RE: Municipal Addition No. 2, Tract 1-A

> 8920 Lomas Boulevard NE Case No: 18-06-0860A

RE: MUNICIPAL ADDITION NO. 2, TRACT 1-A -- 8920 LOMAS BOULEVARD NE

This is in response to your request for a Letter of Map Revision based on Fill for the property referenced above.

CG-101

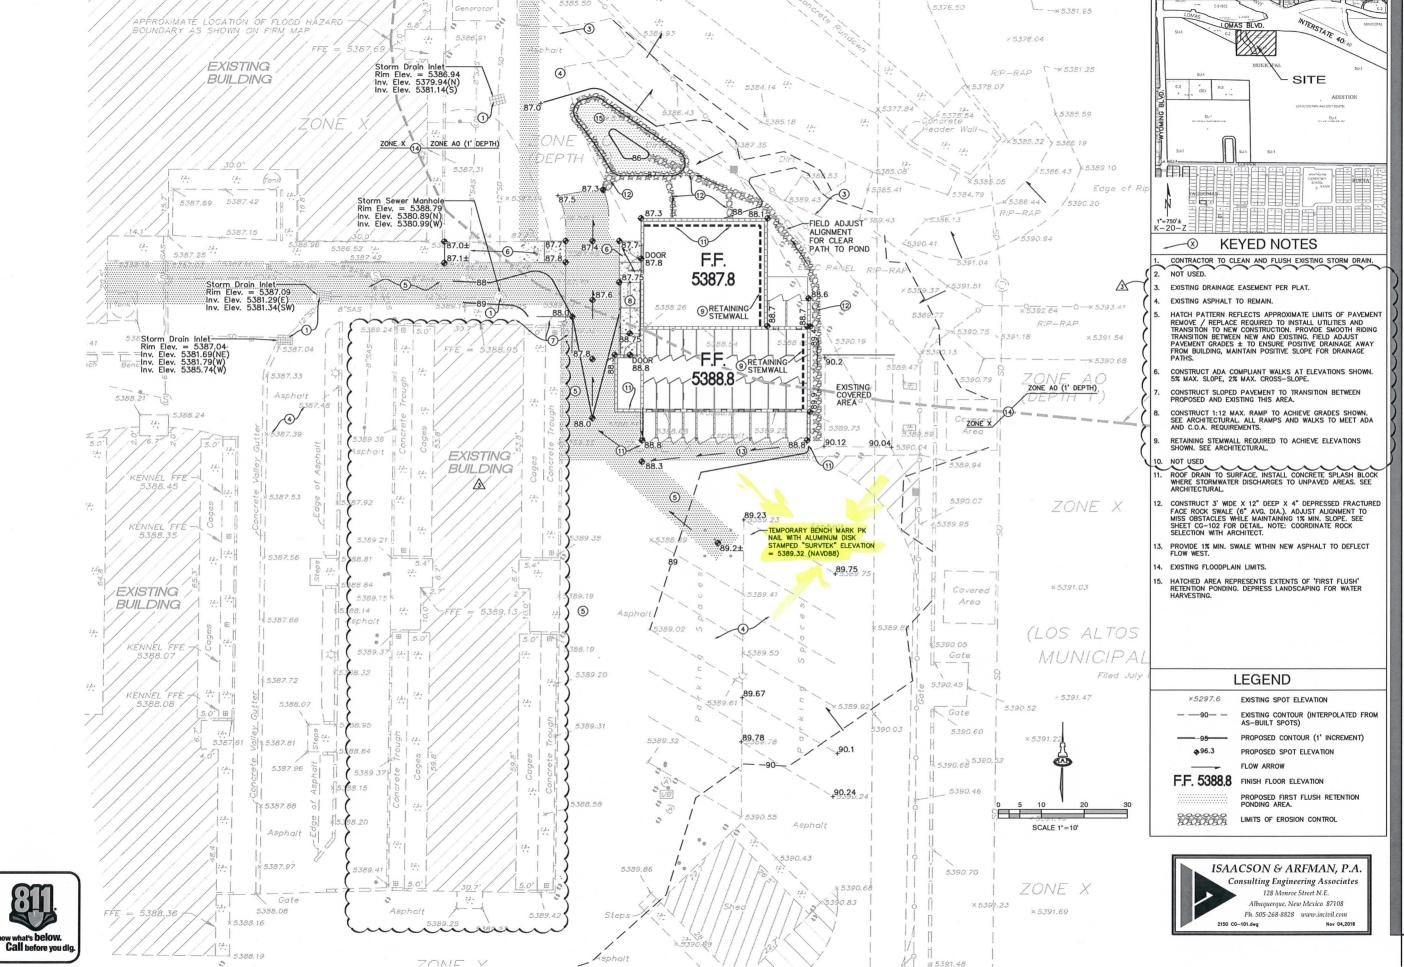
Please have the licensed land surveyor or registered professional engineer add the Vertical Datum to the submitted Grading & Drainage Plan. The surveyor or engineer must initial and date next to any revisions to an original document. Additionally, please have the engineer confirm whether the elevations on the aforementioned plan labeled "existing spot elevations" are in-fact pre-fill spot elevations. Alternatively, if the pre-fill conditions are not represented on the submitted map, please have the surveyor or engineer provide a certified map showing detailed pre-fill topography throughout the property.

Attached is the as-built grading & drainage plan that was originally submitted. I have highlighted the project benchmark with the NAVD 88 datum called out. No changes were needed, therefore no initials were added.

It is confirmed per the surveyor that the "existing spot elevations" were for the pre-fill conditions. A certified map showing detailed pre-fill topography is not required. As a clarification, the smaller italicized elevations are the as-built elevations.
